Harden Environmental Services Ltd.
4622 Nassagaweya-Puslinch Townline
Moffat, Ontario, L0P 1J0
Phone: (519) 826-0099 Fax: (519) 826-9099

Our File: 9506

July 16, 2015

**Re: Proposed Hidden Quarry
Peer Review on Behalf of the Concerned Residents Coalition
Hunter and Associates May 15 2015**

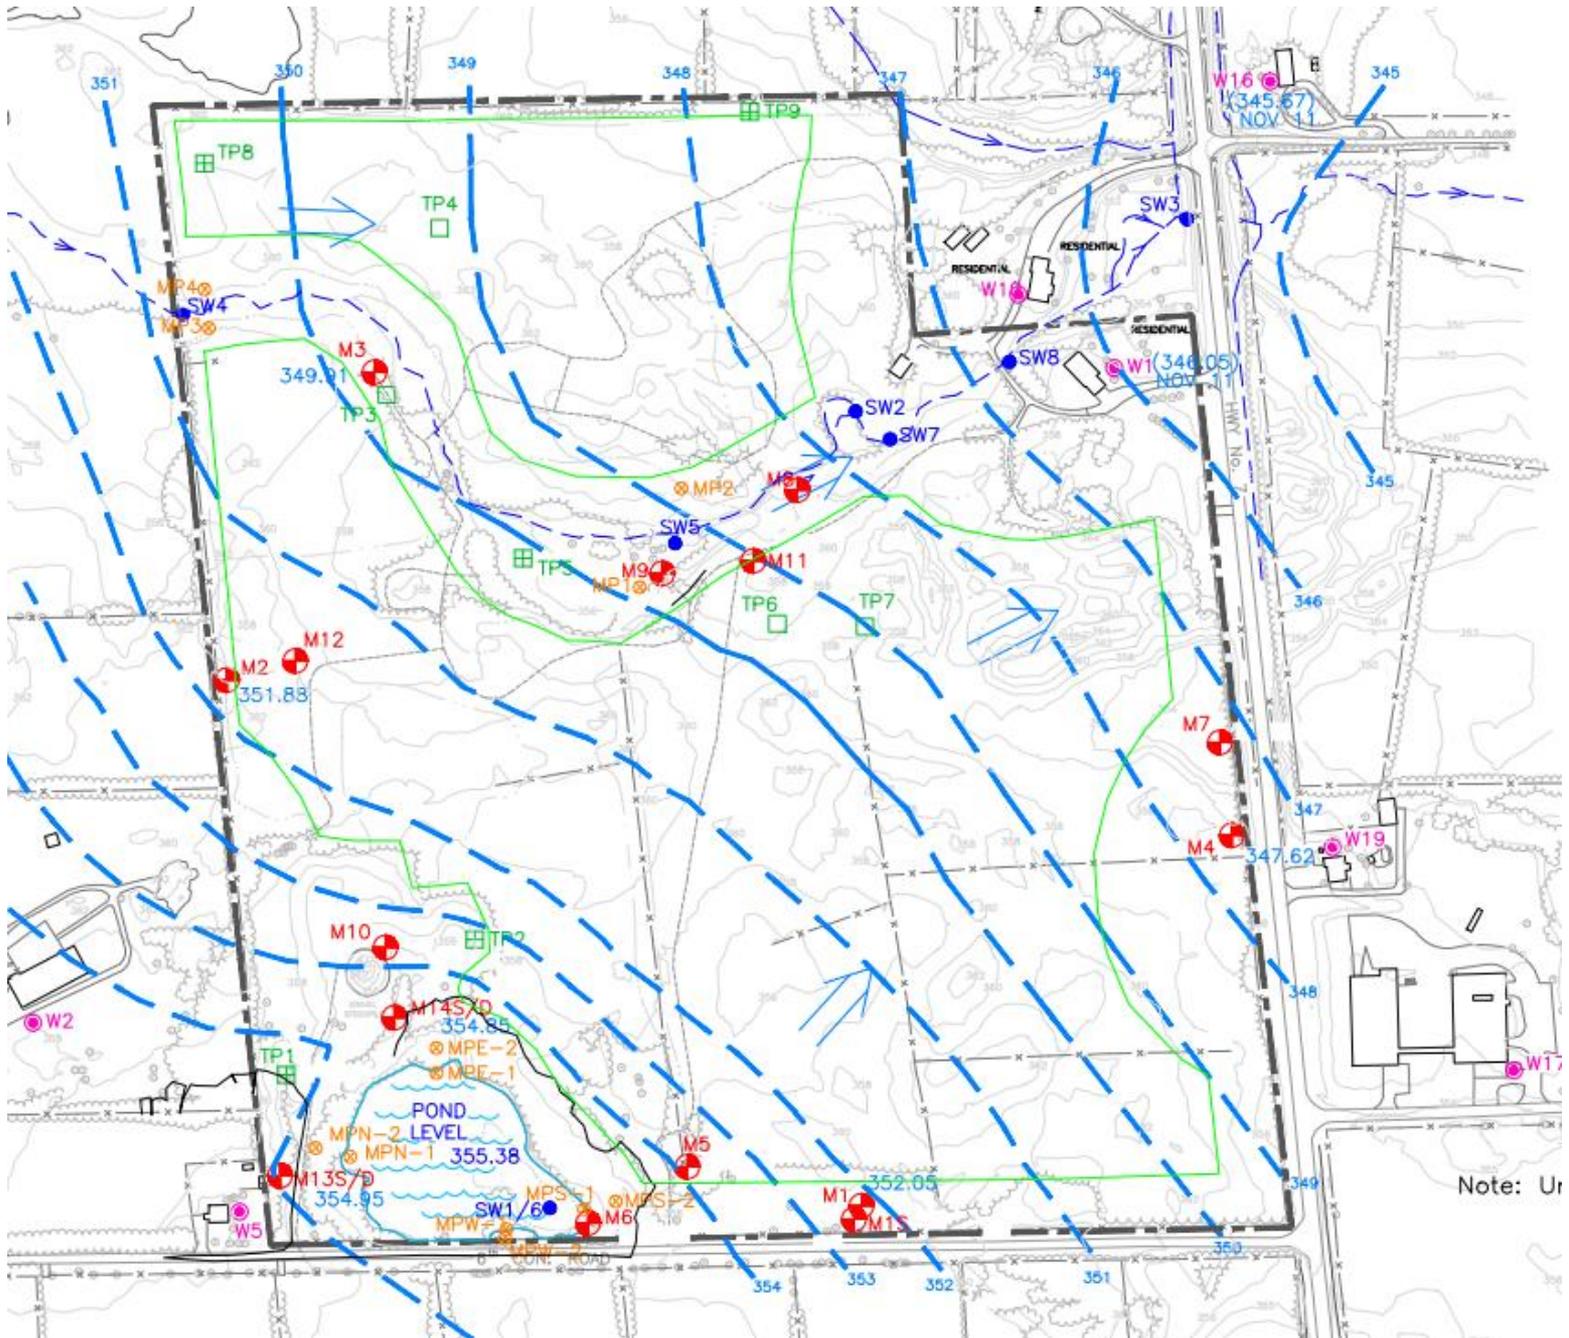
6.1 New Groundwater Monitoring Wells

Evaluation by hydrogeologists from the Ministry of the Environment and Climate Change, Halton Region, the Township of Guelph-Eramosa and the Grand River Conservation Authority resulted in the addition of four monitoring wells at the site. In addition, James Dick Construction has agreed to modify/replace monitoring well M3.

The purpose of the existing and additional monitoring wells is to provide verification of water level change during extraction and verification of the maintenance of water quality standards. Detailed contingency and mitigation plans will be invoked should water levels or water quality changes exceed threshold values.

In addition to the on-site monitoring network, James Dick Construction Limited has agreed to 1) off-site streamflow monitoring of Tributary A and B and 2) include select private wells where accessible and with owner permission.

Where needed, trigger levels will be developed for the monitoring wells and included on the site plans prior to commencement of quarry activities.
